West Winch Housing Access Road Detention Basin Survey Update Technical Note

Document Reference: ncc/3.11.01N

Version Number: P01

Date: February 2024

Figure 11 - Basin 6 design based on LiDAR

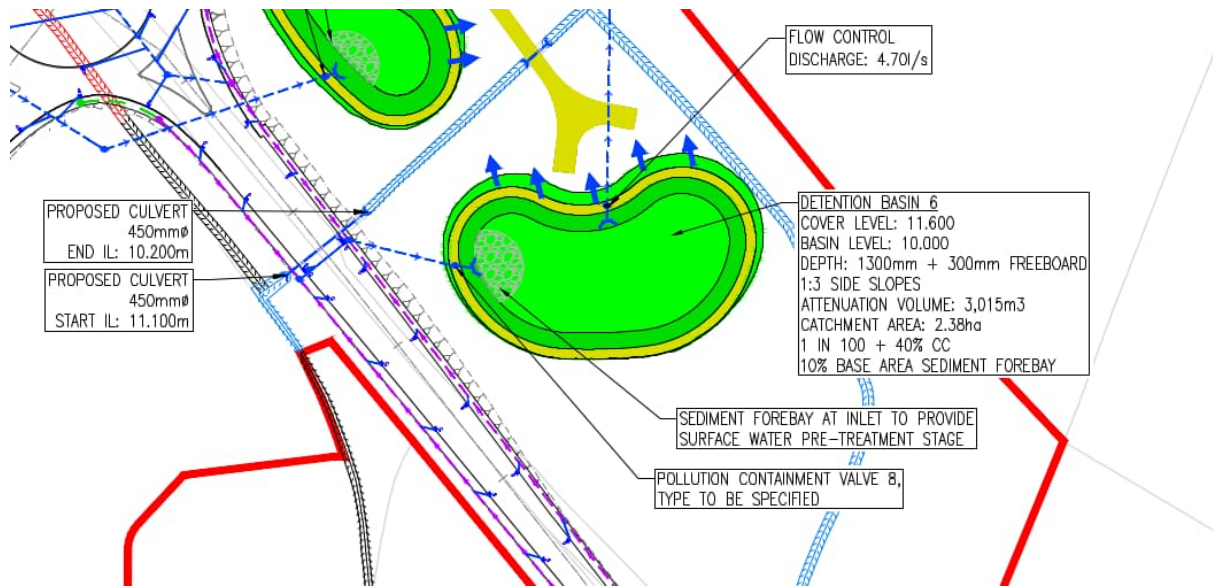
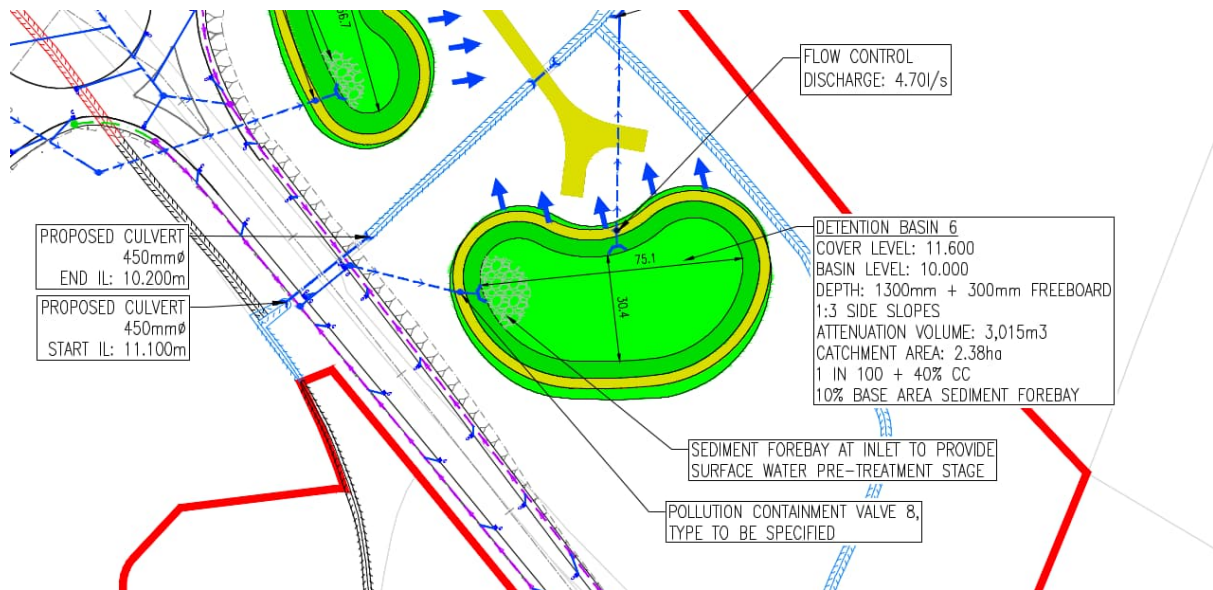
3.7.1 For basin 6, to the south, level differences between the two surveys are minimal, typically between 50 and 100mm, with some areas less than +/- 50mm.

3.7.2 Due to the similarity in levels, both the cover levels and invert levels have remained unchanged. The only modification made is to the earthworks area, which whilst the extents have changed – the overall area has remained consistent at 426m². The change in extents shown does not detriment the drainage strategy nor other design aspects of the proposed Access Road.

Figure 13 - Basin 7 design based on LiDAR

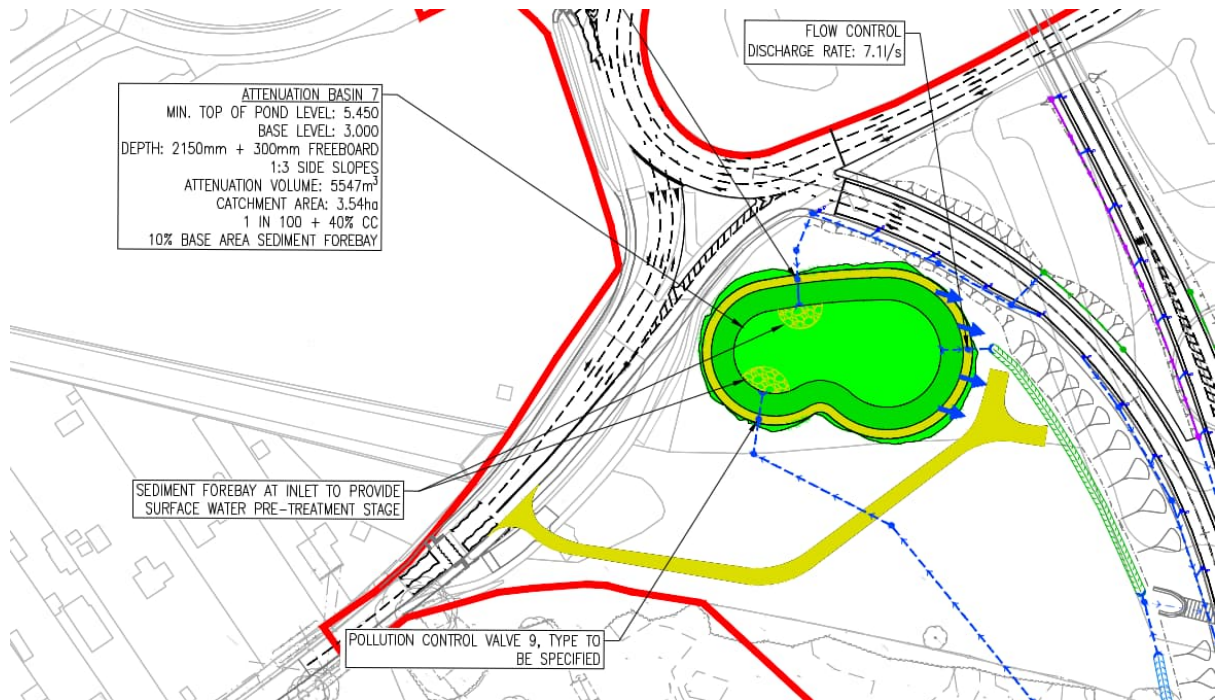
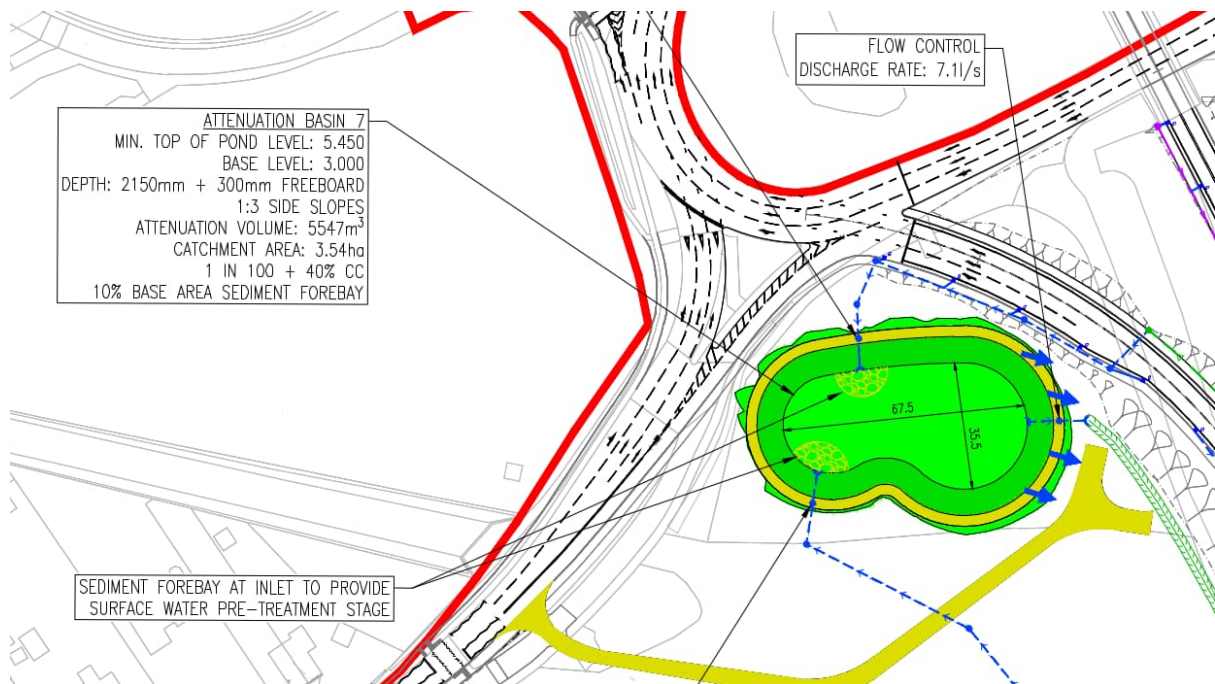
3.8.1 Basin 7 is where the greatest differences between the two surveys are found, with level differences typically up to 300mm, with some small, isolated peaks

where differences are in excess of 500mm, likely due to the presence of vegetation which has been picked up at surface of the LiDAR survey. This was expected in this area due to the dense vegetation on the ground and the presence of mature trees, which will have reduced the accuracy of the LIDAR survey in isolated areas.

- 3.8.2 As levels for Basin 7 are different to the LiDAR survey, this is likely to impact on the earthworks design of the basin. Most surveyed levels are in the range of up to 300mm lower than the design levels, therefore the cover level of the basin has stayed the same and the footprint of the basin has increased in some areas to tie into the existing in-situ levels.
- 3.8.3 Both the cover levels and invert levels have remained unchanged to achieve the required attenuation volumes. The only modification made is to the earthworks extents required to tie into existing levels, which have experienced a slight increase (12%) in area from approximately 332m² to 373m². The change in extents shown does not detriment the drainage strategy nor other design aspects of the proposed Access Road.
